Proposed Upgrade to Masterton Wastewater Treatment Plant

Response to Further Information Request by the Greater Wellington Regional Council

Figure Q13.1: Daily and Weekly Leakage Compared with River Flows

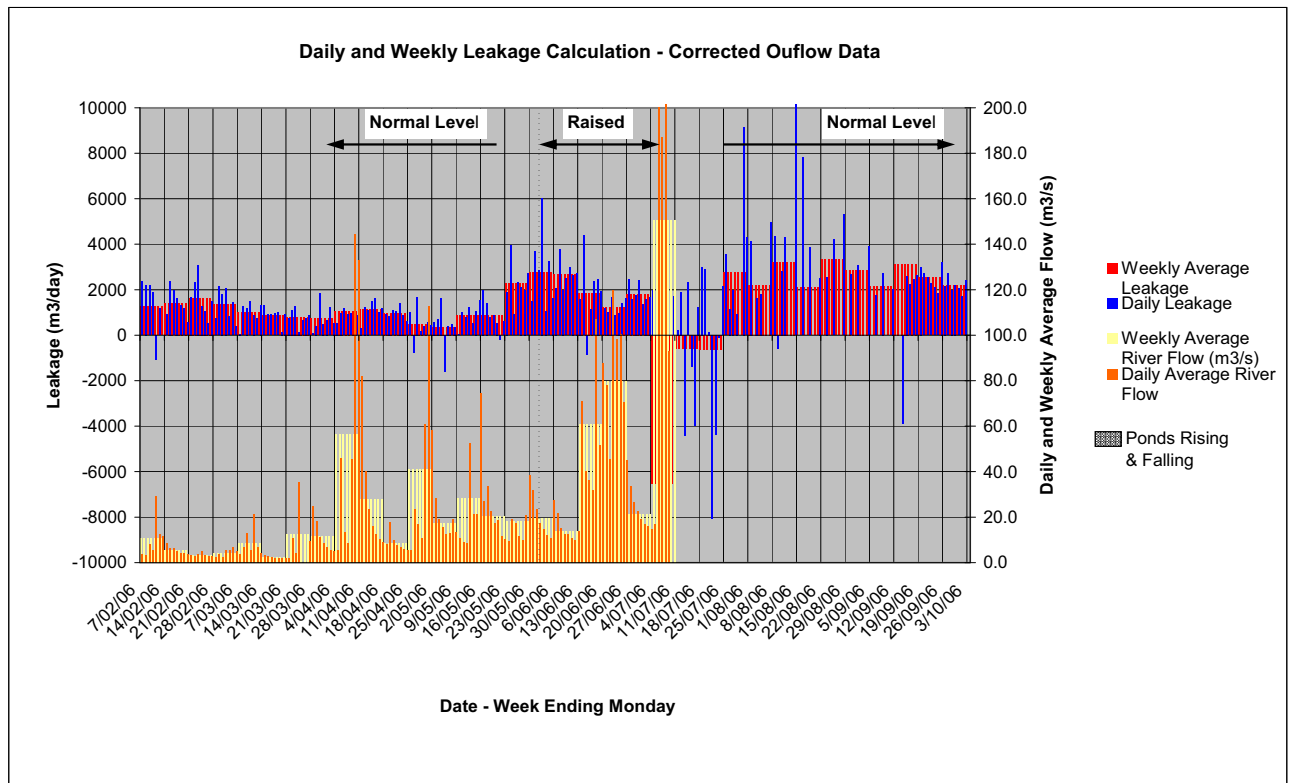
Given that pond seepage and infiltration rates are closely correlated with flows in the Ruamahanga River, please comment on the validity of the pond leakage estimates provided and, if appropriate, submit a revised worst-case daily leakage volume.

Pond leakage is affected by the head difference, so leakage will be greater when the ponds are high and/or river is low, from basic fluid mechanics considerations. However, when the average daily and weekly river flows at Wardell's were plotted against the calculated leakage flows (see Figure Q13.1 next page), there is not an obvious pattern, despite a significant amount of effort that was made to correlate pond river flows and leakage flows.

The lack of correlation is probably a function of the errors inherent in the calculation of the leakage (see *Wastewater Pond Leakage Estimate*, Pattle Delamore Partners, 2007). Essentially, the inherent accuracy limitations of the flow measurement devices results in uncertainties obscure the more subtle changes in leakage induced by the head changes due to changes in river levels. However, the general picture suggests that there is not a large change in river level between a flow of a few m^3/s and several tens of m^3/s (of the order of 0.5m), and that the early phase of the leakage experiment is a reasonable representation of leakage for low to moderate river flows: i.e., around 800 $\text{m}^3/\text{s} \pm 900 \text{m}^3/\text{s}$, as per the report.

Given the head difference between the pond and river of between about 3 m opposite Pond 1 and 5m or more opposite Pond 3/4, a difference of a 0.5m of head will not induce much change in leakage, assuming a linear relationship (as per Darcy).

In conclusion, submitting a revised leakage estimate is not appropriate because the estimate is considered to be valid, with the estimate range already sufficiently generous to cover any variation in small river level changes.

Figure Q22.1: Predicted P and N Loads to River Before and After Upgrade

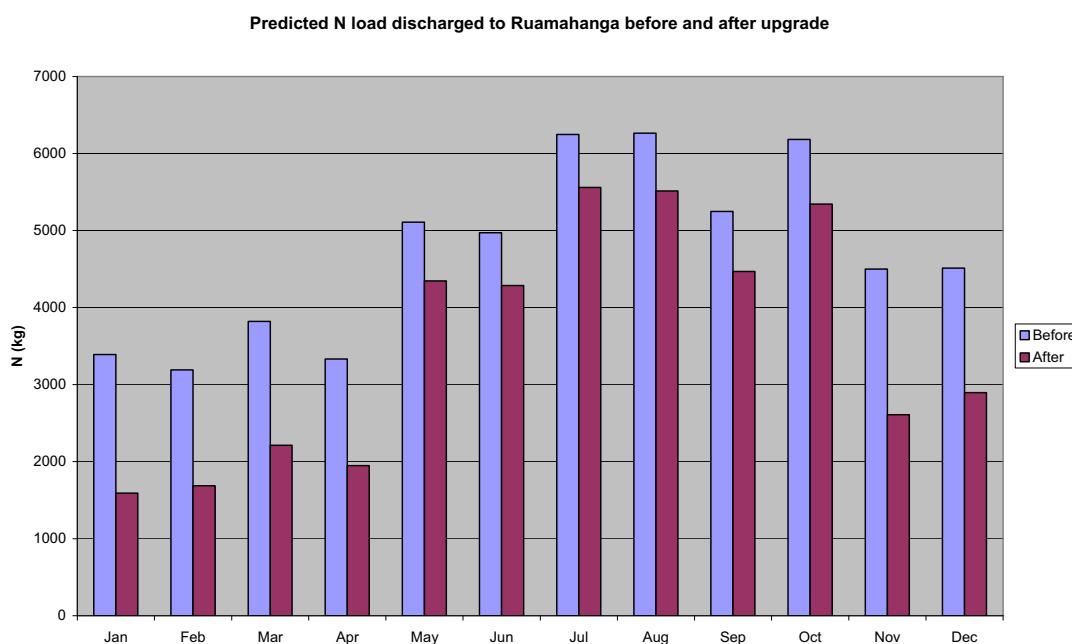
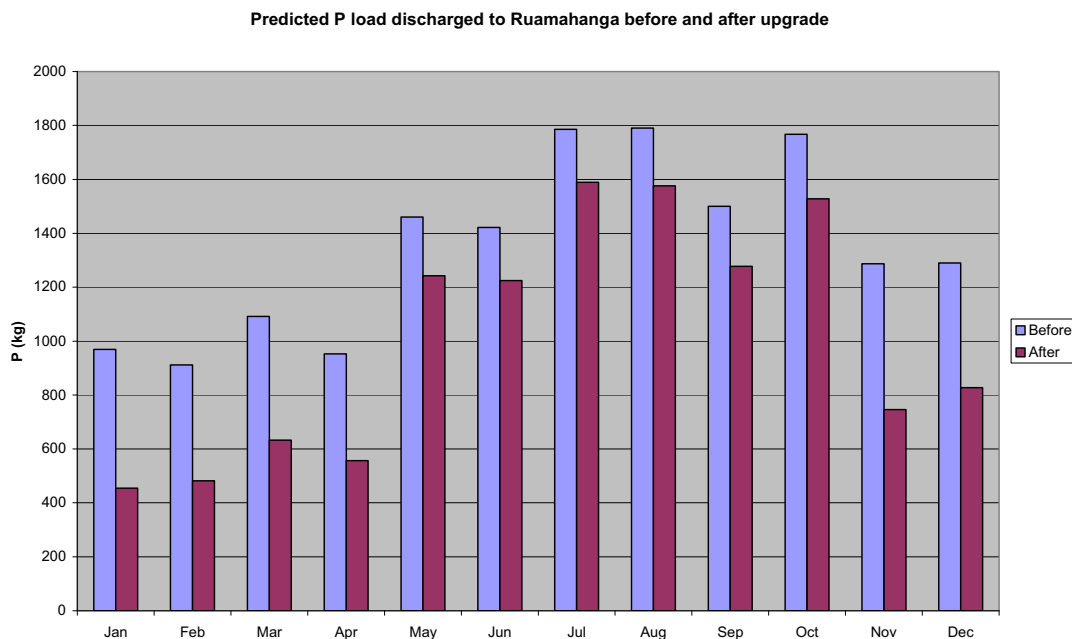
Your assessment of the effects of the effluent and pond seepage discharges on the river is based on contaminant concentrations only. Concentrations alone do not indicate the complete picture of effects as they do not take into account discharge volume. In responding to the question above, please clearly specify the date range for the existing effluent data and the effluent volumes used in the calculations. To represent the worst-case effluent discharge scenarios, it is expected that the minimum dilution (30 x) will be used for both the discharge at just above median river flow and the discharge at the maximum possible rate (1,200 L/s).

The reduction in nutrient load is, however, distributed unequally throughout the year, with greater reductions in summer (when effluent is dominantly irrigated). The Figures below illustrate the 'average' monthly TP and TN loads before and after the upgrade.
